ACR Torque for 110 and 103 P&A Cylinder Heads

It is possible that some ACR equipped P&A 110 (1800 cc) and 103 (1690 cc) cylinder heads were shipped with the ACR partially torqued.

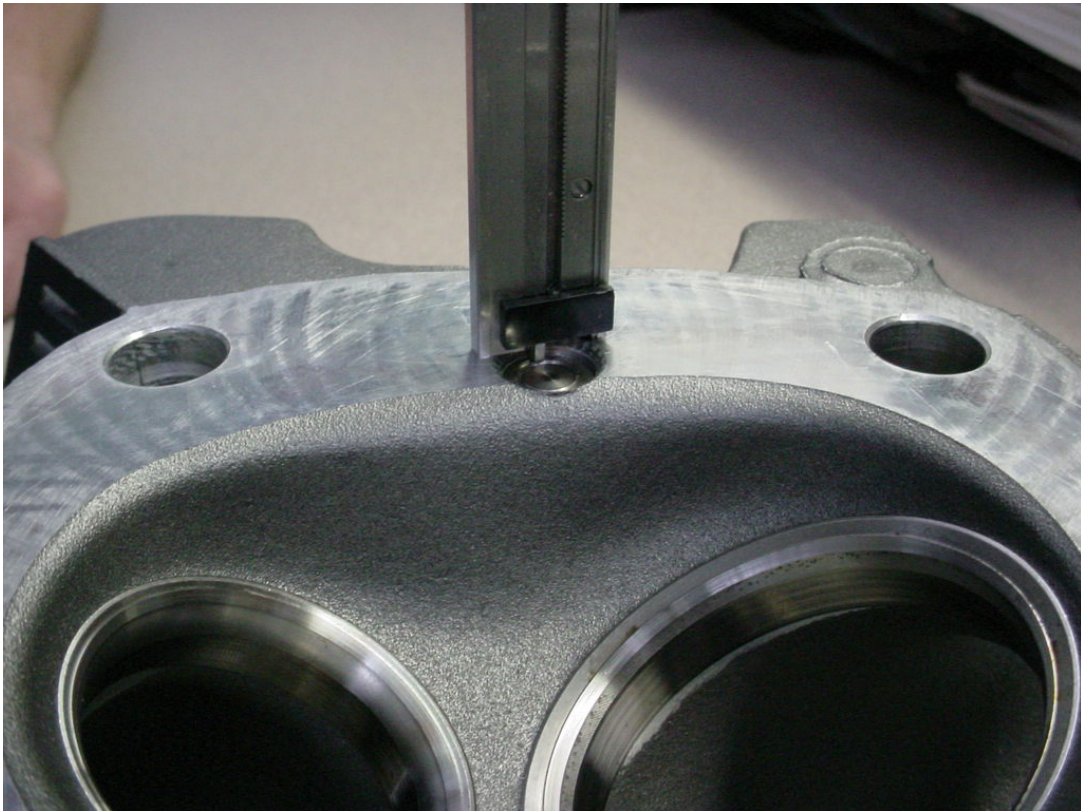
Before installation or retail, please check all heads to ensure that the ACR is properly seated. This can be achieved by simply measuring the depth to the ACR from the head gasket surface of the cylinder head. A properly torqued ACR will measure .080"-.090" from the head gasket surface to the ACR.

If the automatic compression release is more than .090" from the surface of the cylinder head dome, the component should be removed from the head, cleaned and reinstalled using the ACR socket tool (Part Number **HD-48498A**)

1. Verify that the copper seal washer is in place on the ACR.
2. Identify a location around the threads of the ACR approximately 1/3 of the way up from the end.
3. Apply three equally spaced dots of LOCTITE 246 (blue) on threads.
4. To prevent cross threading, install and finger tighten.
5. Using ACR solenoid socket, tighten to 11-15 ft-lbs (14.9-20.3 Nm).
